## Planning Commission Staff Report

**SUBJECT:** DR18-124, POWER TRAINING CENTER

Approve the Findings of Fact and approve, DR18-124 Power Training Center: Site plan, landscaping, grading and drainage, elevations, floor plans, lighting, colors and materials for approximately 0.94 acres, generally located at the southeast corner of 144th Street and Pecos Road, and zoned Business Park (BP).

WALL PANEL TRANSITION DETAIL No Scale 1

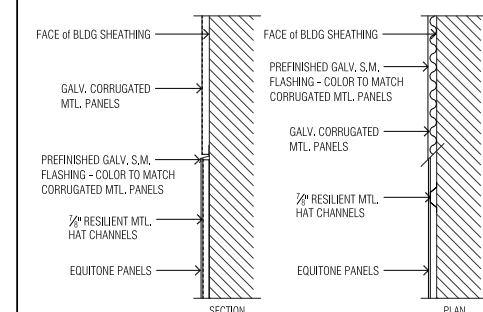
thing. He asked how they would handle where the corrugated portion butts up against the fibrous cement. He said they don't appear to be there yet on the details, but he would want to make sure that they weren't seeing the edge of the corrugation from below. He would appreciate seeing more detail. He said he thought they could get more detail about the fascia detail. He said it seems like it's tacked on in terms of the massing. He suggested whitening that up a bit to make it more prominent. He also asked if they were using that to shade.

BUILDING ELEVATIONS (000)

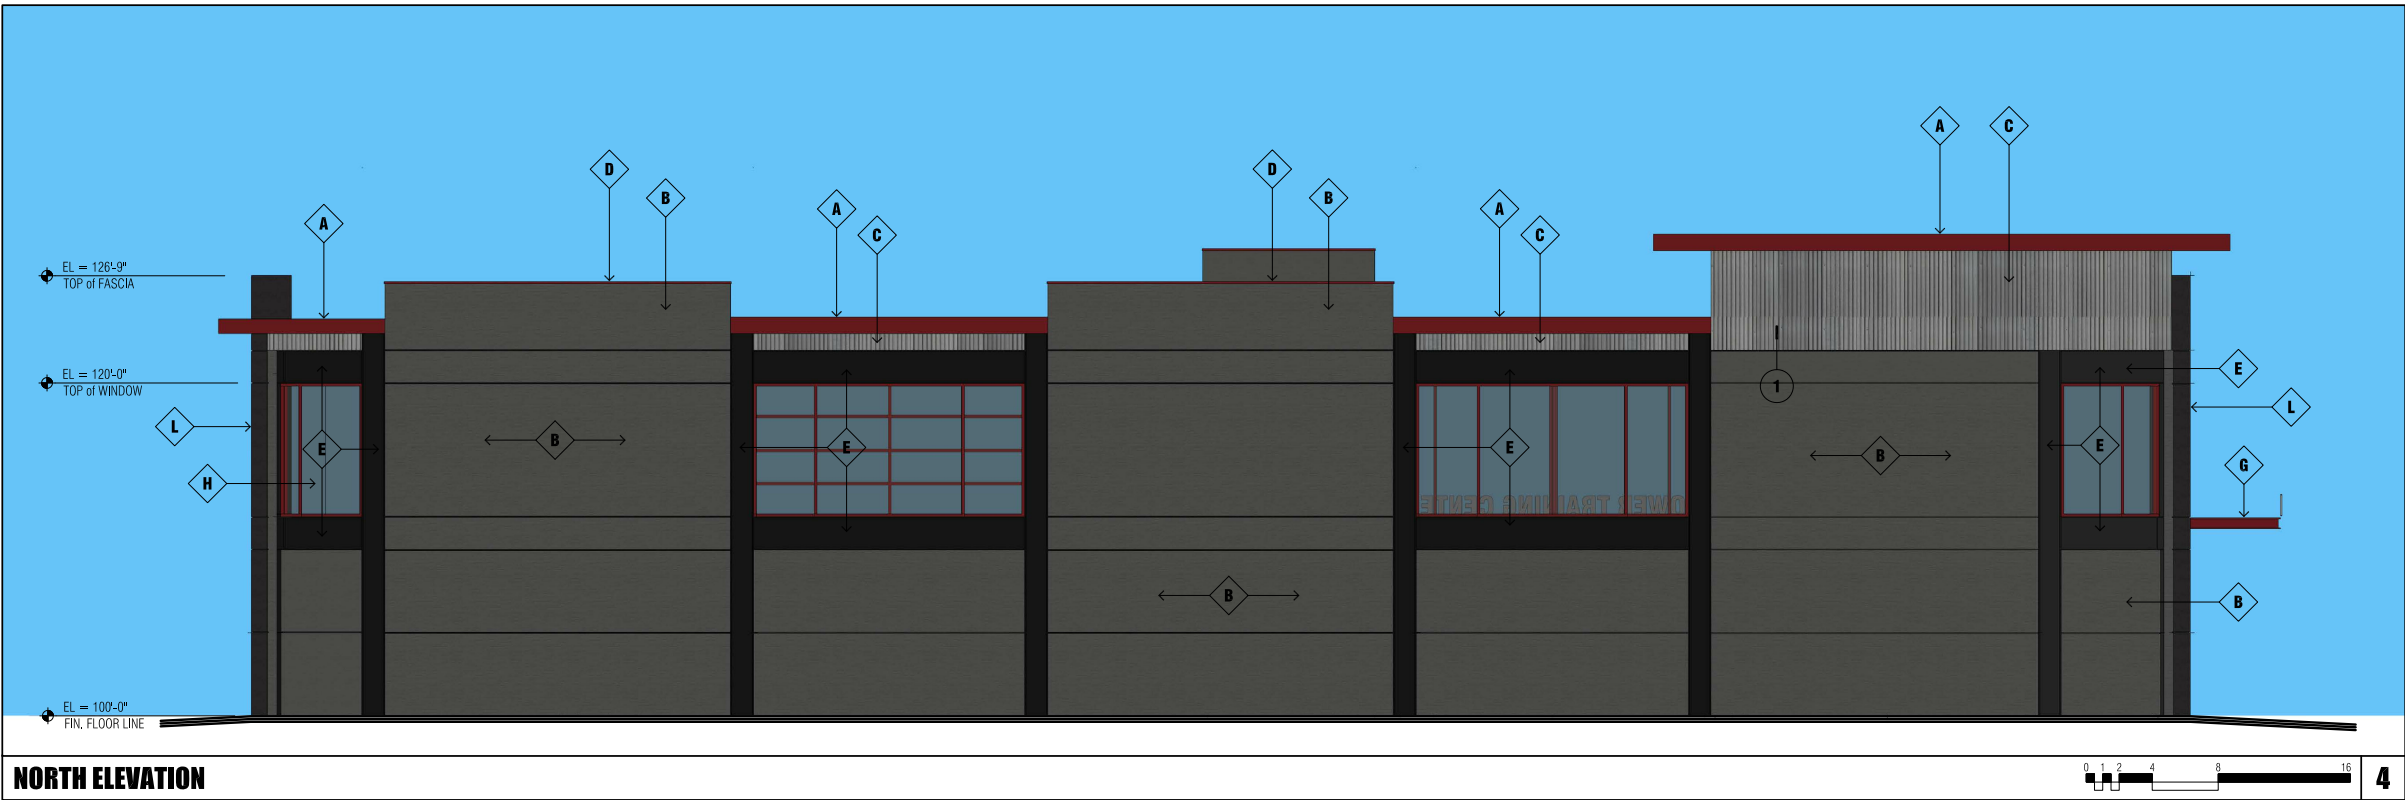
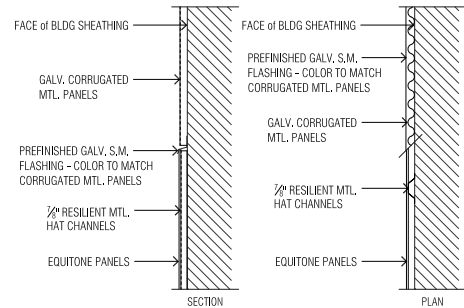
Question: Brian Johns asked about the fibrous material, noting that they usually stucco it or treat it in some way, but he asked if this was actually exposed.

Comment: Brian Johns said there are a lot of details and elements shown, but he doesn't know how they plan to apply those details and elements to the building. He also asked about how they were handling the downspouts.

Comment/Question: Daniel Cifuentes said he wanted to commend the applicant on the use of the Equitone fibrous cement panel. He said it would require less maintenance, which is a good

Question: Brian Andersen asked about the south elevation. He said it looks like there is a big overhead door facing the parking lot where the handicapped spaces are located. He asked what the purpose was for that.

Question: Brian Andersen asked about the front entry storefront color. He said he would hate for the applicant to think they could use that red and then when they start construction, find out that they can't use the red. He said the paint doesn't really hold to aluminum that well. He then asked about the window head heights and the roll-up door heights. He said they seem pretty close to the top of the parapet. He said that indicates that there isn't a lot of room for structure and for the parapet to screen the mechanicals on the roof. He said he would have the applicant verify that there is enough parapet up there to screen the mechanical walls.

Answer: Nathan Williams said he didn't know how it was actually constructed. He said he thought it came in whatever size sheets that you want it to. He said he wasn't certain how it was applied to the framing.

Response: Nathan Williams said he would look into that. He said he thought they were trying to be creative in dealing with drainage since they don't allow exposed downspouts.

Answer: Nathan Williams said the red were cap elements which would provide shade. He asked to clarify if the Commissioner was suggesting a different tone.

Answer: Nathan Williams said that he believed it was a roll-up door. He indicated the location of the training area on the floor plan. He said he thought during ideal weather conditions, the door might be open during training sessions.
